ADDENDUM NO. 3 TO PROJECT NO. 44782

ELECTRICAL WORK PROVIDE FIRE ALARM AND EMERGENCY VOICE EVACUATION SYSTEM EMPIRE STATE PLAZA ALBANY, NY 12242

May 2, 2025

| DRAWING NUMBER: | F-C-118 |

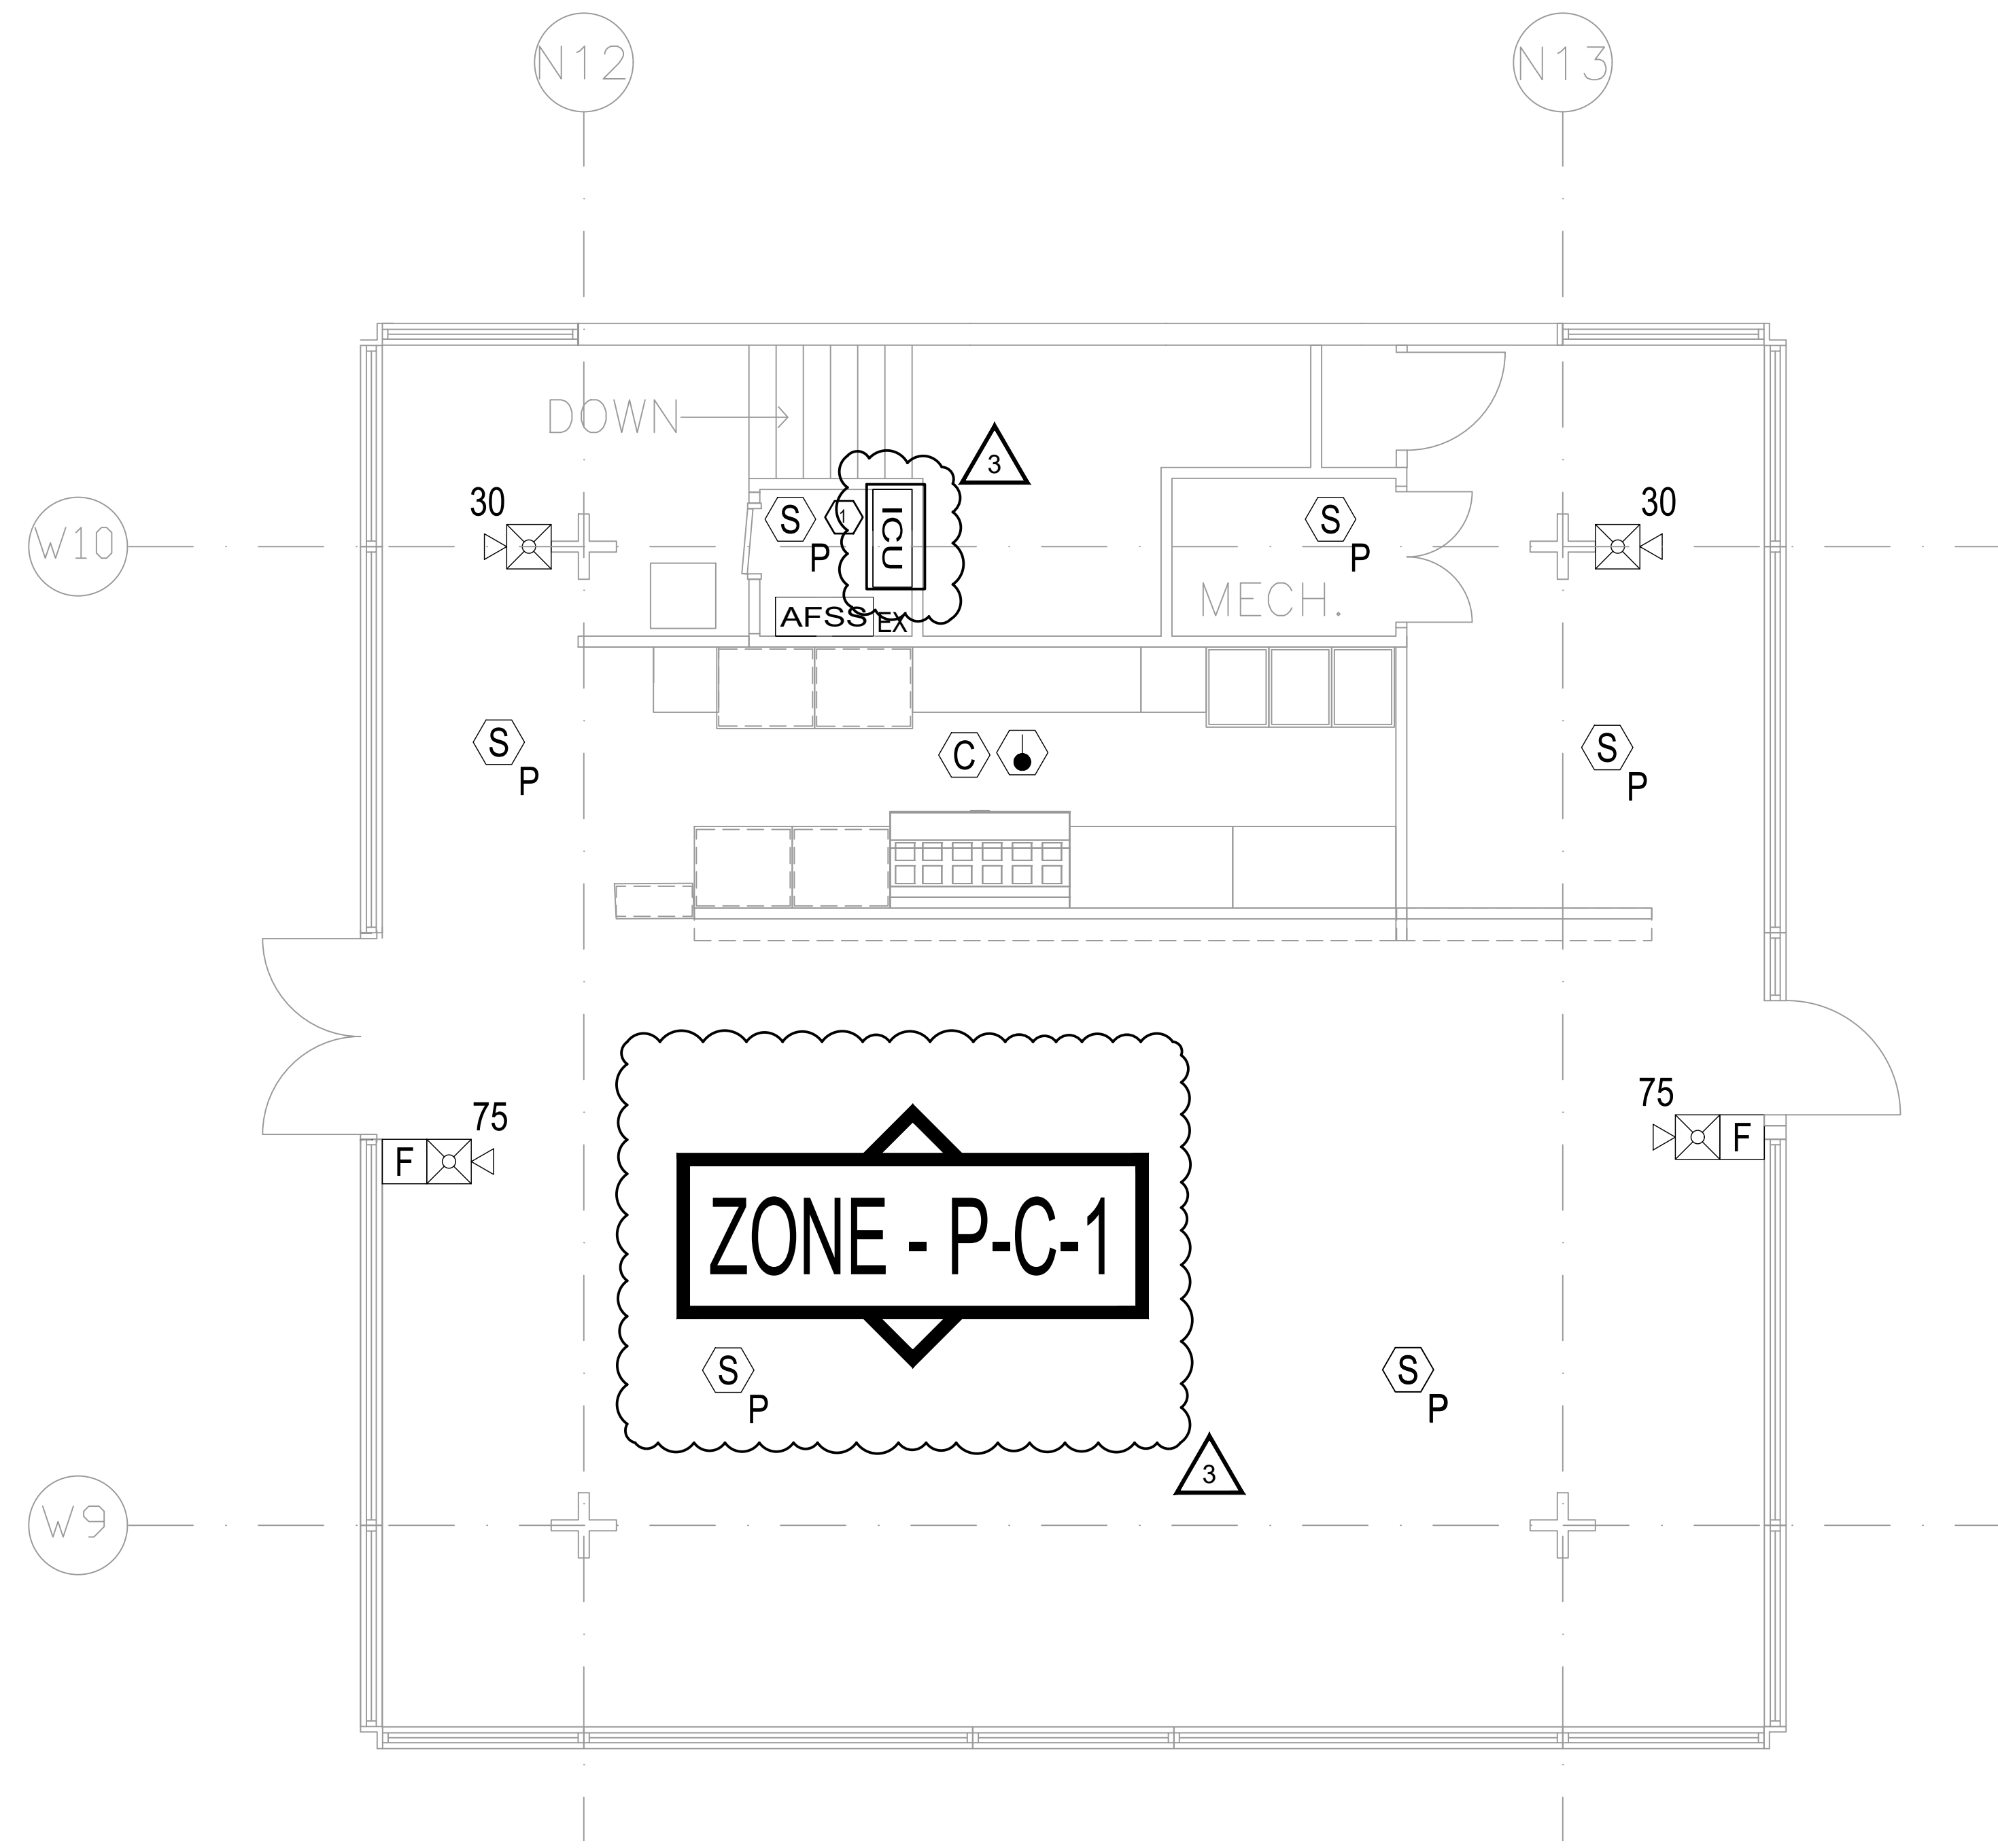
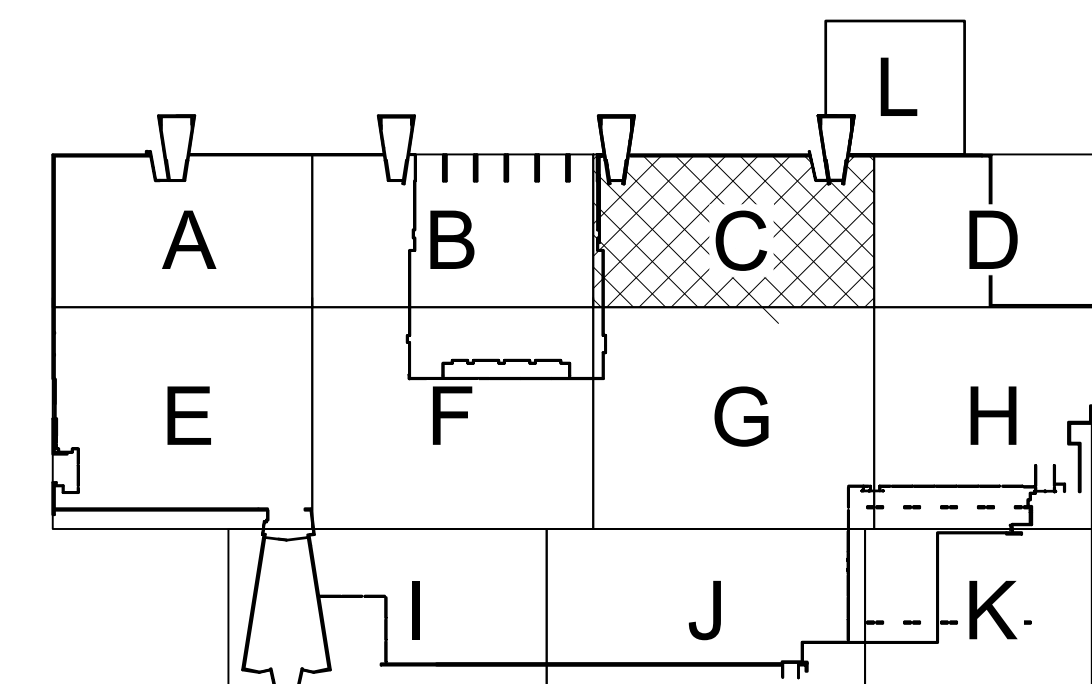
- EXISTING ANSUL KITCHEN AUTOMATIC FIRE SUPPRESSION SYSTEM SHALL BE PROVIDED WITH AN ADDRESSABLE INPUT MODULE.

1 ESP SITE-WIDE REPORTING RISER DIAGRAM
SCALE: N.T.S.

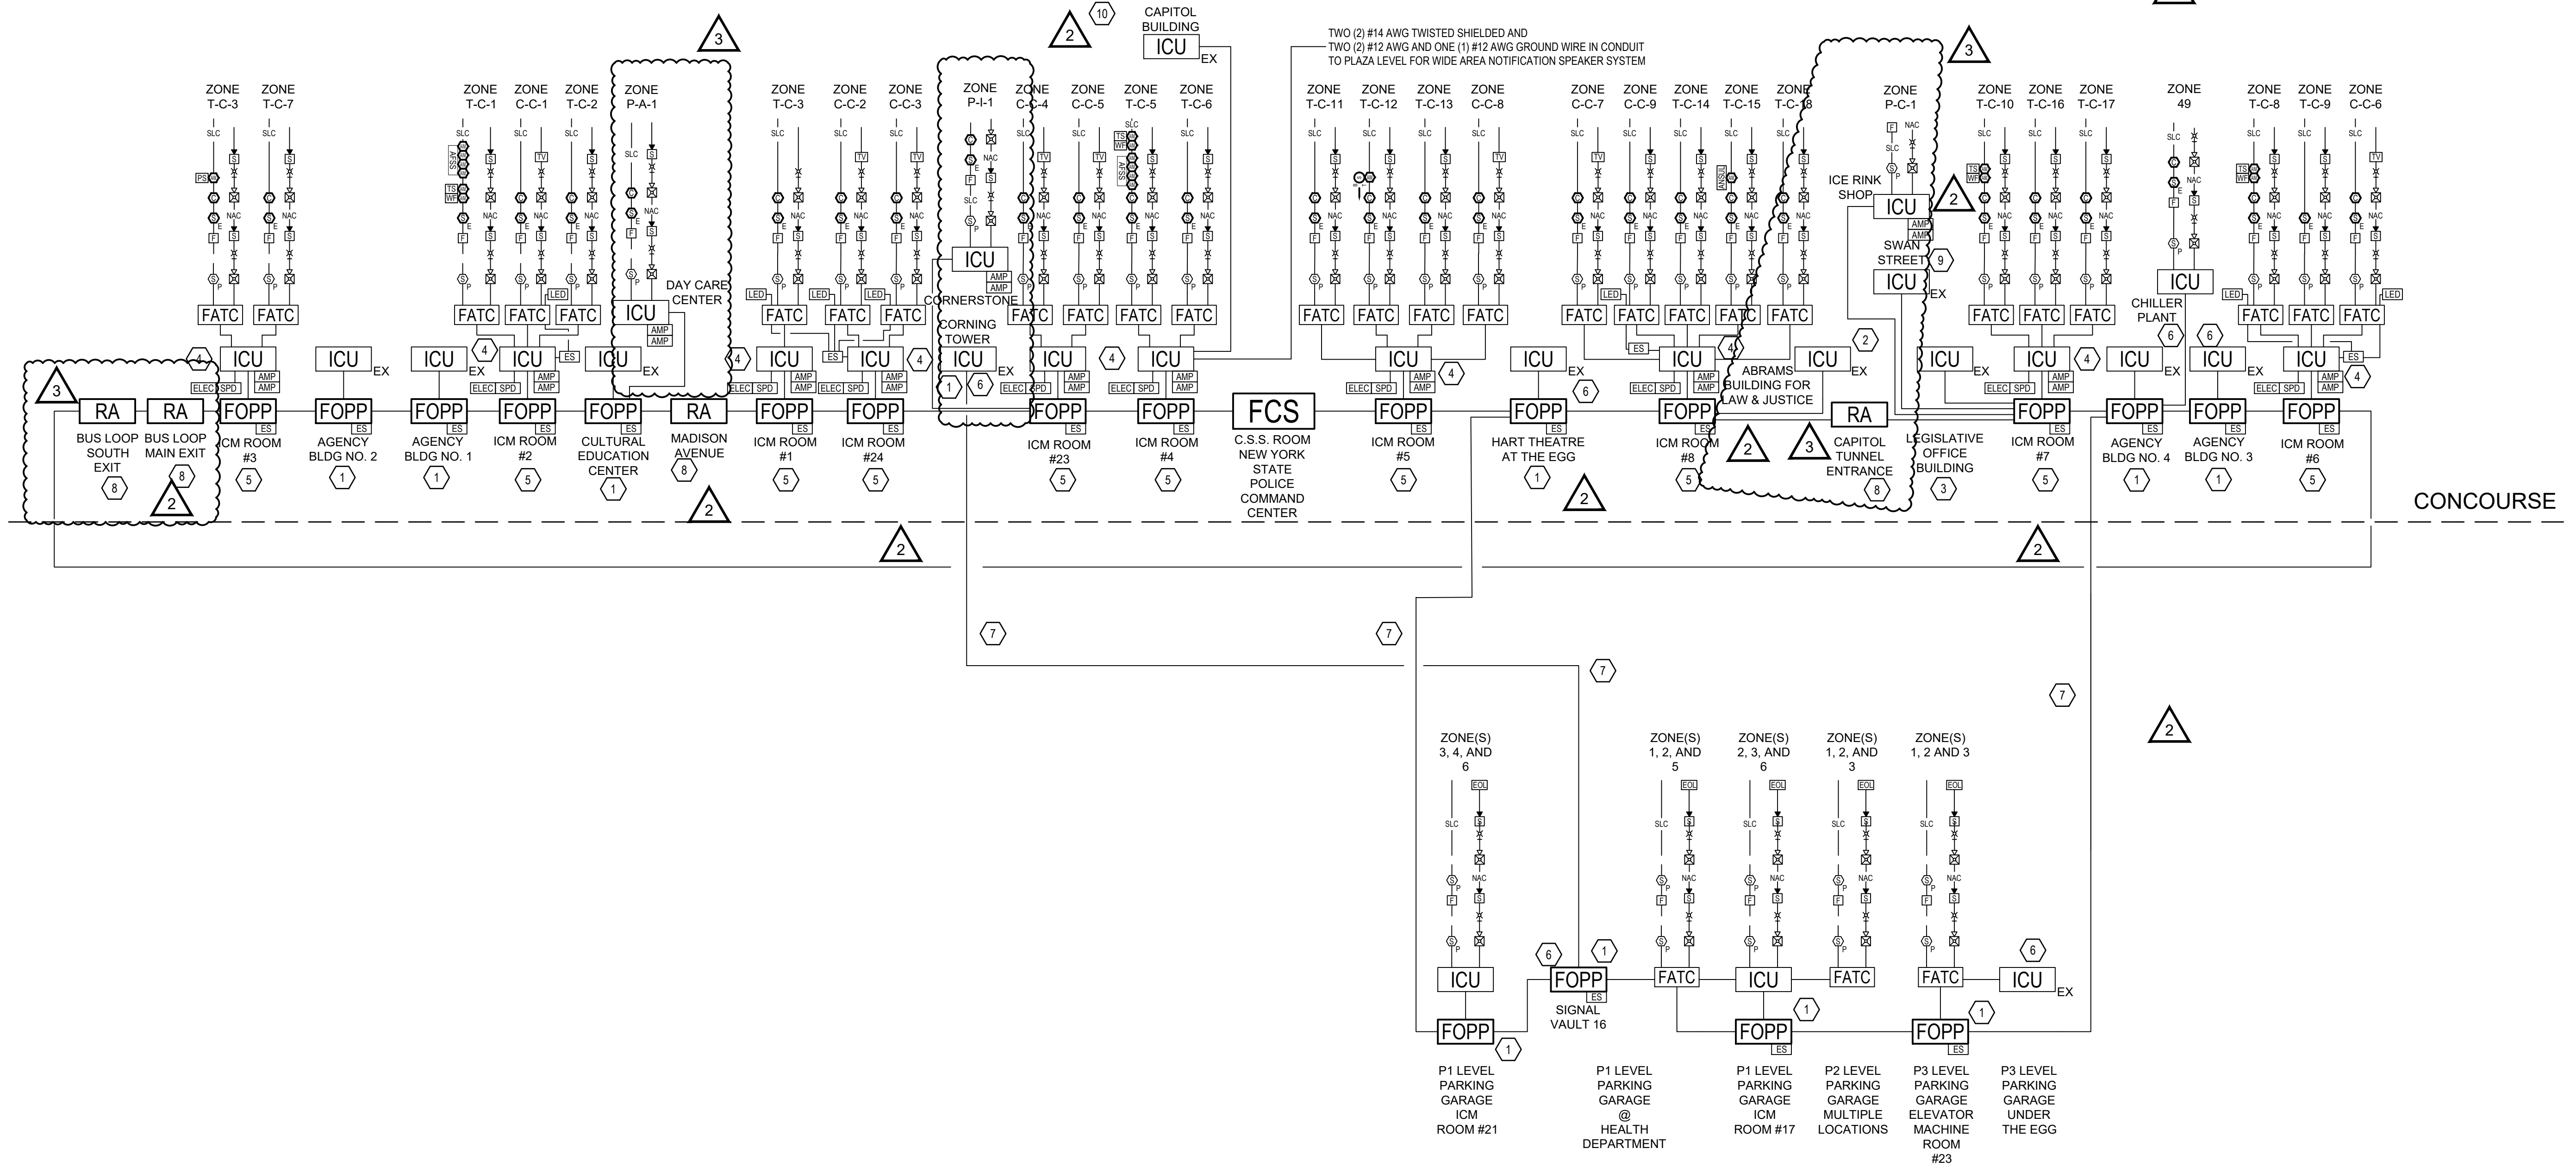
- FIBER OPTIC PATHWAY ADDED TO SHOW CONNECTIVITY FROM CONCOURSE LEVEL TO PARKING LEVELS.
- REMOTE ANNUNCIATORS (RA) ARE TO BE PROVIDED AT THESE FOUR LOCATIONS. SEE SHEET NOTE 3 FOR ADDITIONAL POWER REQUIREMENTS.
